KEYSPAN CORP - ROCKAWAY PARK, QUEENS, NY
LOCATION = NEW YORK

**Rockaway Park Former Manufactured Gas Plant Site
Rockaway Park, Queens County, New York**

Review of Submittal

**Signed and Stamped Foundation/Anchoring System and
Revised Procedures for the Relocation of Temporary Fabric Enclosure**

BB-1

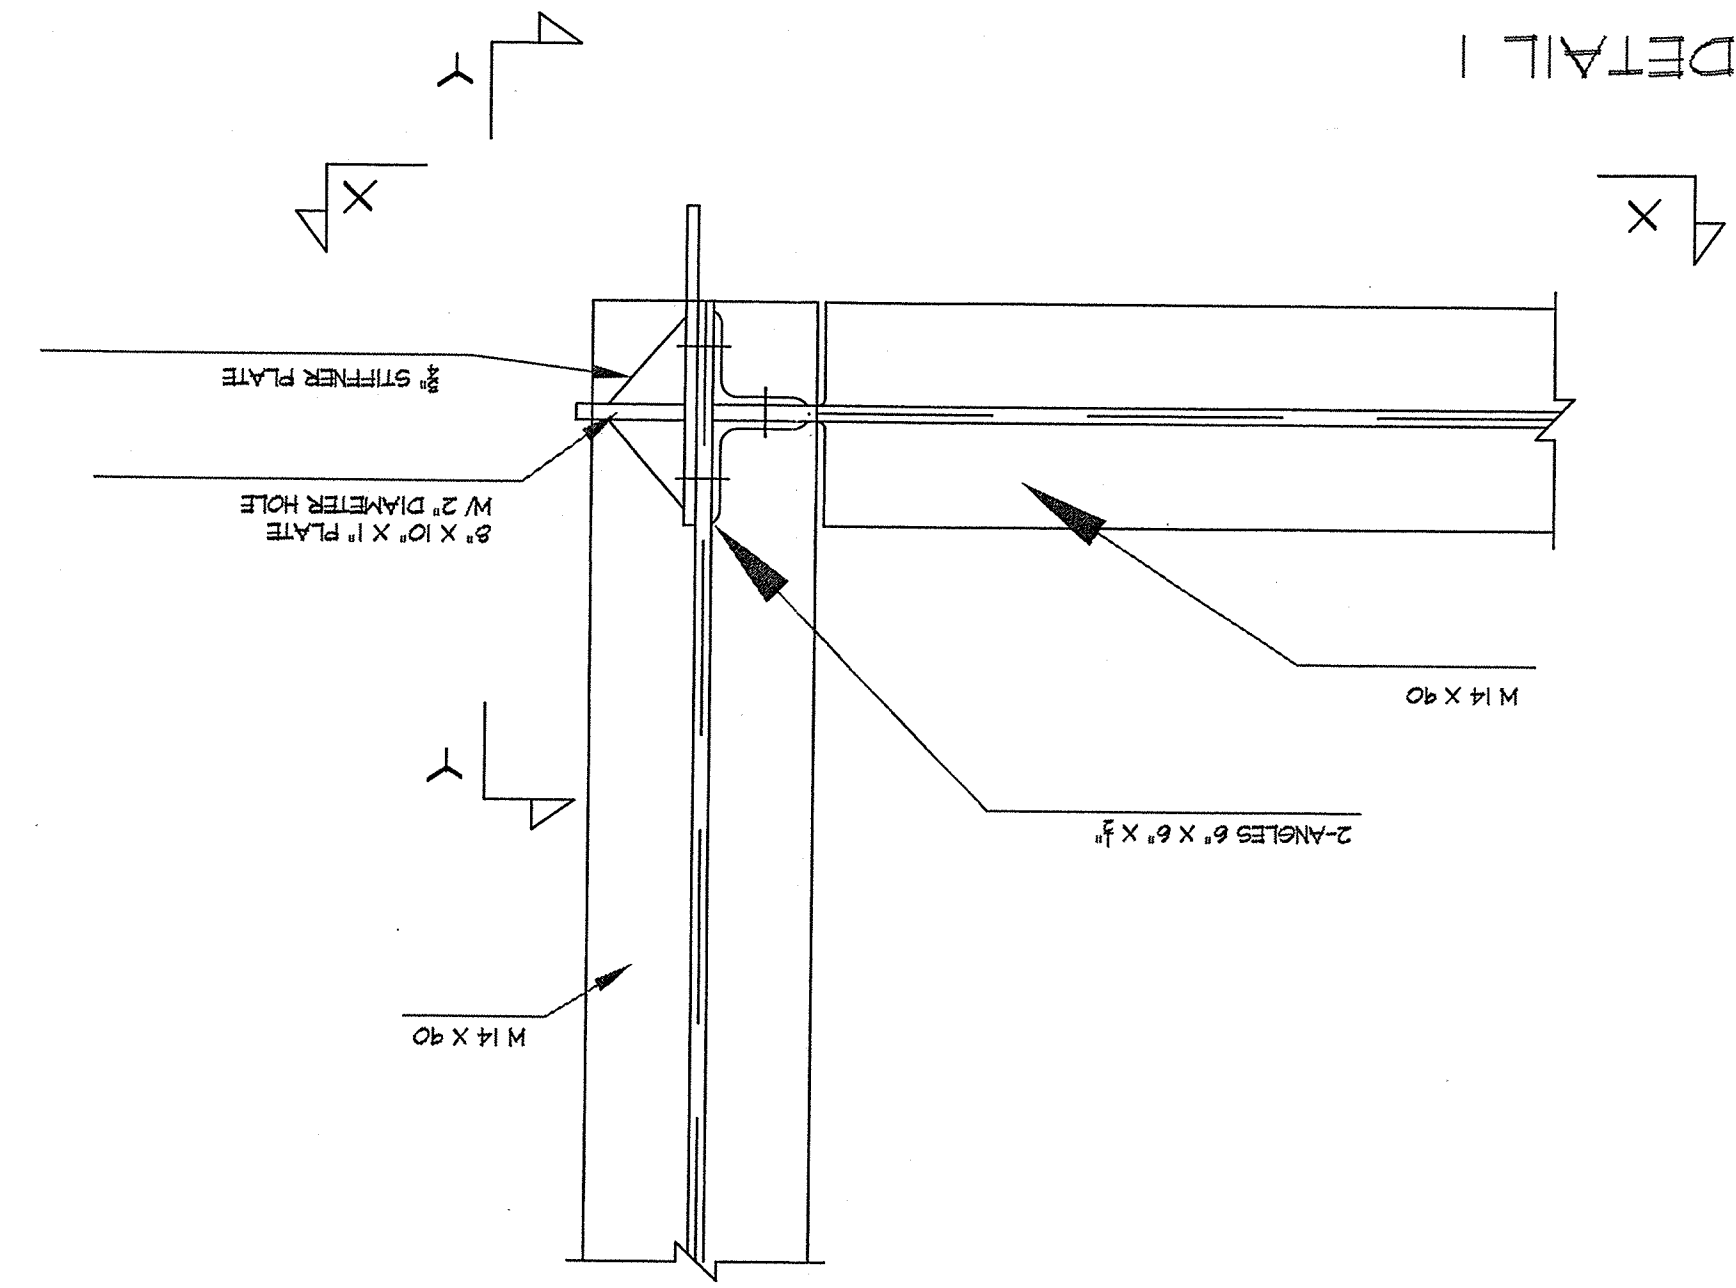
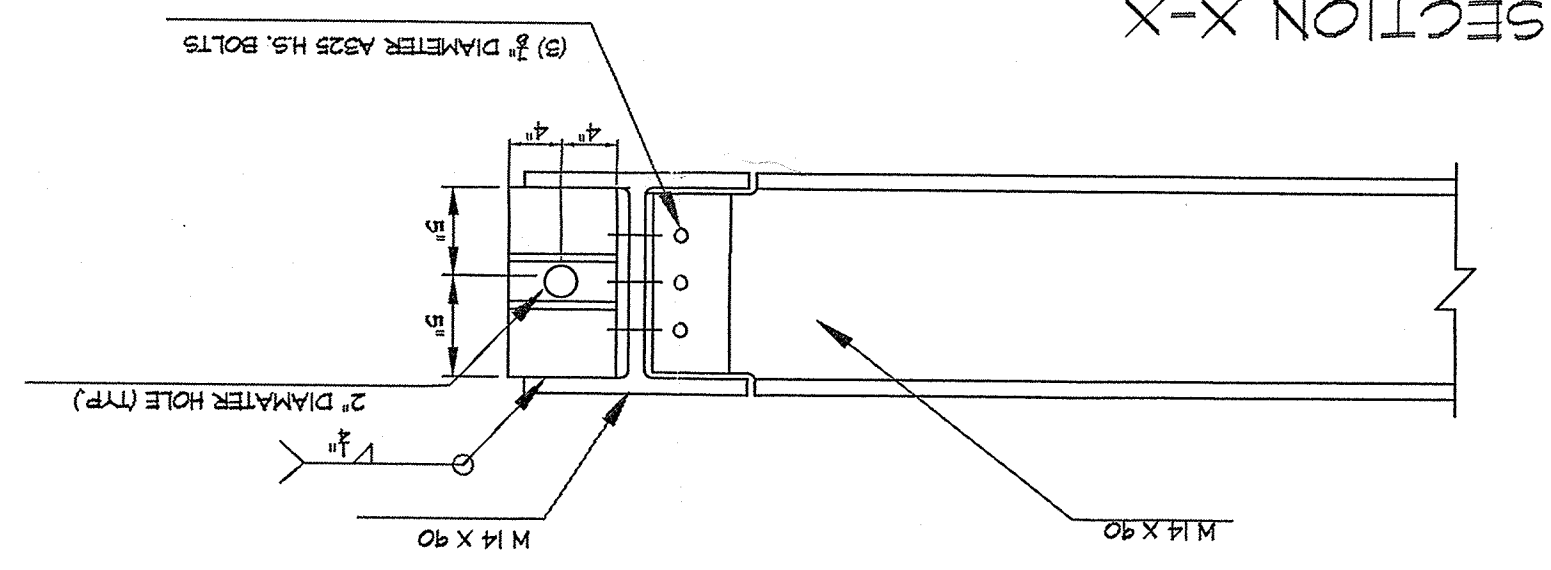
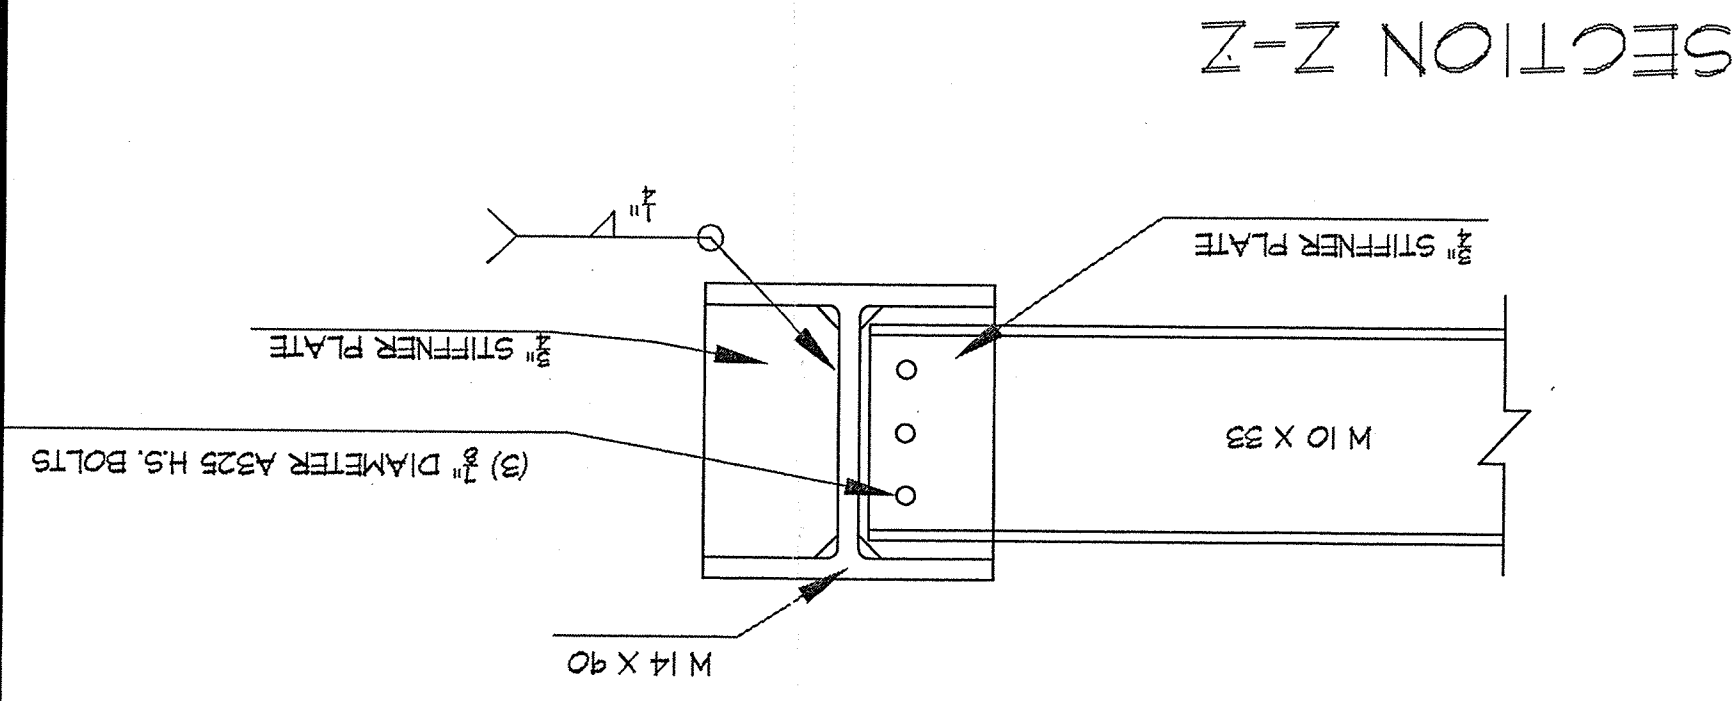
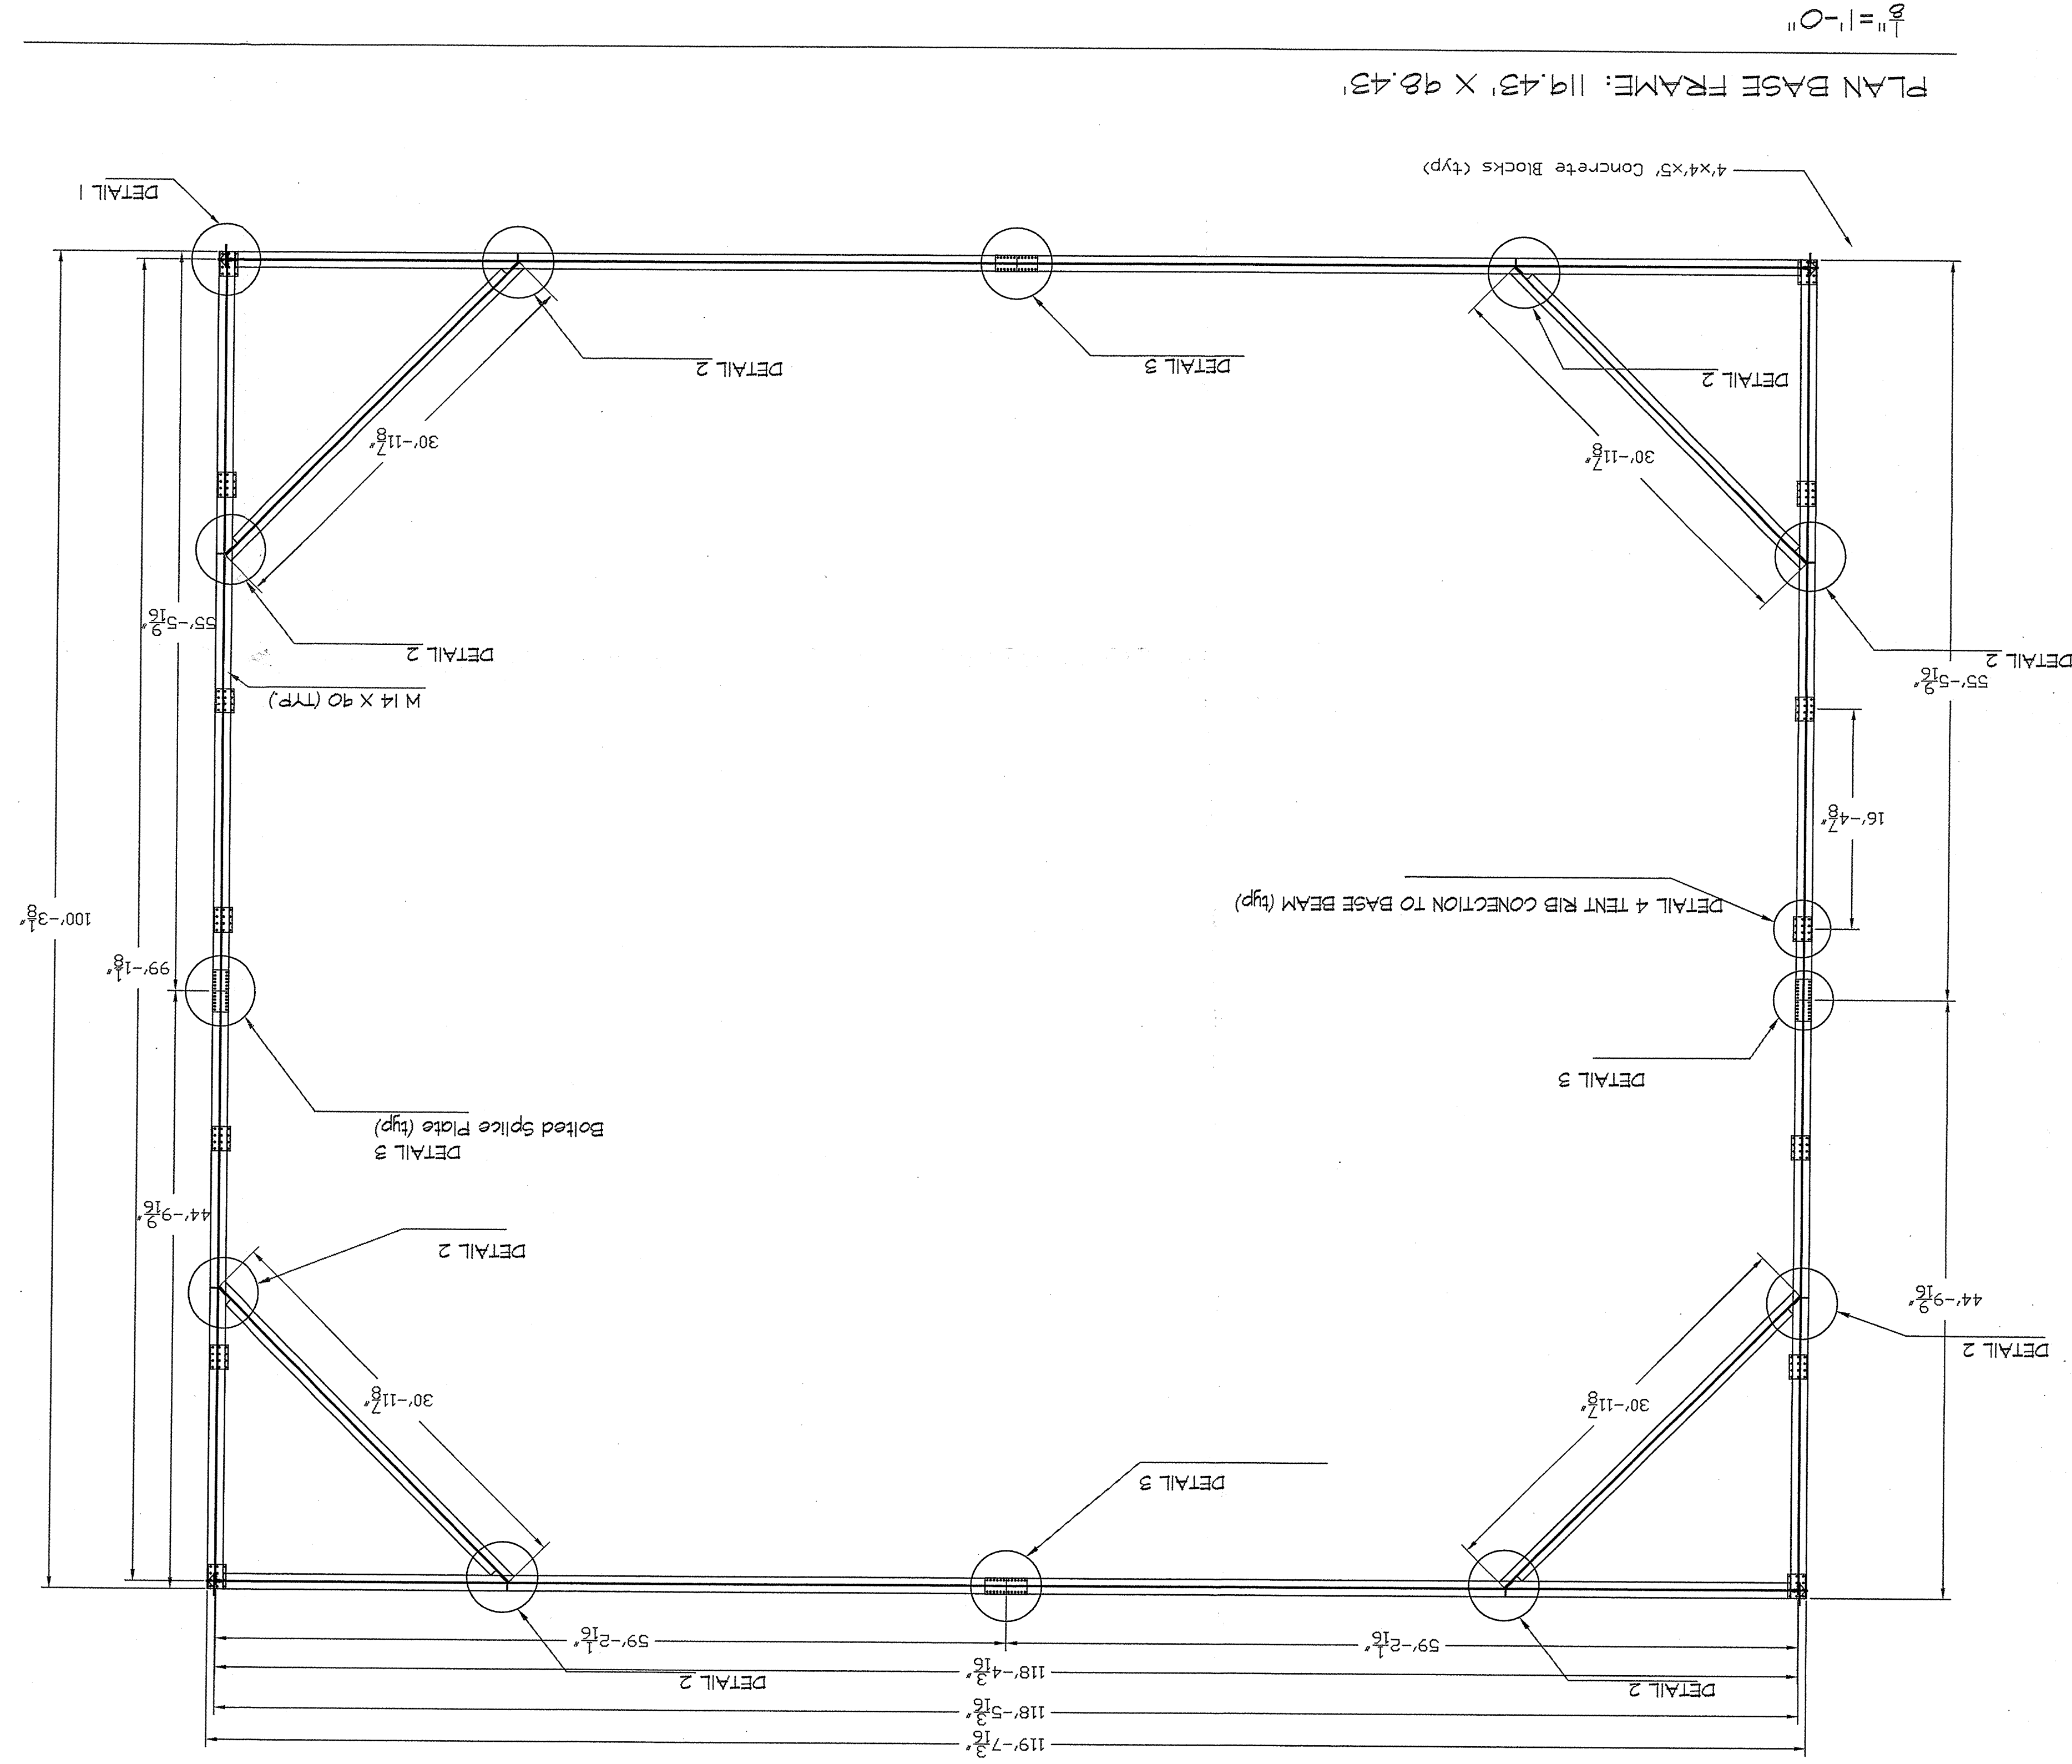
- (1) Ballast Block Calculation – No comments.
- (2) Posillico submitted a drawing, Drawing BB-1, which presents the proposal to supplement the tent base beam to add support to aid in the proposed relocation procedure. The intent of the supplemental support is to allow the tent to be relocated in either direction without the need for a crane-pick. Posillico has stated that they were working in conjunction with Universal on this modification. However, the drawing is presented on a Posillico border that is not signed and stamped by a New York State Professional Engineer. In addition, no information has been included in the submittal that the manufacturer of the enclosure has been consulted, reviewed or approved of this modification. As the modification presents a change to the design of the foundations system for the enclosure, the submittal must include documentation from the manufacturer which notes that they have reviewed the modification and that it will not affect the overall design and performance of the enclosure structure. Further, the manufacturer should be consulted regarding the proposed relocation procedure (see Comment #3). This letter should be signed and stamped by a New York State Professional Engineer.

The process of relocating the structure involves picking the structure up at the center of the cross-beams. No information has been provided to reflect that the current design can support this lifting at the center of the beam.

The process of relocating the structure shows two pay-loaders with forks positioned at the center of the cross-beams. Their purpose is not to pick the structure, but to support the base frame at it's center-point since it will be suspended, due to the use of the timber piles placed perpendicular to the direction of travel. The base frame's cross-bracing is not subjected to the loads from the tent ribs, thereby the pay-loaders are compensating solely for the weight of the base frame.

Posillico has provided a letter from the manufacturer, Universal Rentals, LLC, detailing their involvement in the proposed relocation procedure. Posillico has also supplied a letter with calculations from our NYPE that address the caveats in Universal's letter. The NYPE has based his letter off of drawing BB-1 which he has also stamped and is provided for your use. The letters and drawings supplied also answer the concerns stated in paragraph three.

Drawing BB-1 submitted by Posillico presents a method to relocate the structure by supporting it on a frame that is elevated onto rollers, and then subsequently dragged into position.

The modification presents a change to the design of the foundation system. As long as the frame that is supporting the structure has sufficient stiffness to transfer the structure's loads to the grade, the overall design and performance of the structure will not be affected when supported by this frame.

The structure, once supported on the frame, will be relocated by means of rolling the supporting frame over timber rollers. As long as the frame that is supporting the structure has sufficient stiffness to transfer the structure's loads to the rollers, the overall design and performance of the structure will not be affected.

The rectangular base frame supporting the tent structure is made out of W14X90, Grade 50 beams with a moment capacity of 385 kip-ft for an unbraced length of 24.5 feet. And for the same unbraced span of 24.5 feet the beam can safely carry a total uniform load of 125.5 kips (By interpolation from table on page no. 2-117 of AISC Manual, 9th edition), equivalent to $125.5/24.5 = 5.12$ kips per lin. foot of the beam.

The total weight of the tent structure is 47.425 kips. The tent ribs are perpendicular to the shorter length (98'-0") of the frame. Therefore, the maximum uniform load per lin. foot of base beam from the tent structure is $(47.425 \times 1.5^*) / (2 \times 98) = 0.363$ kip/ft., which is much smaller than the allowable 5.72 kip/ft.

As depicted in the Procedure for movement of the tent structure the base beam will always be supported on 12" diameter timber poles at 10' intervals. This spacing of the timber poles acting as rollers could vary up to a maximum of 15 feet and still be structurally safe to withstand the weight of the tent structure.
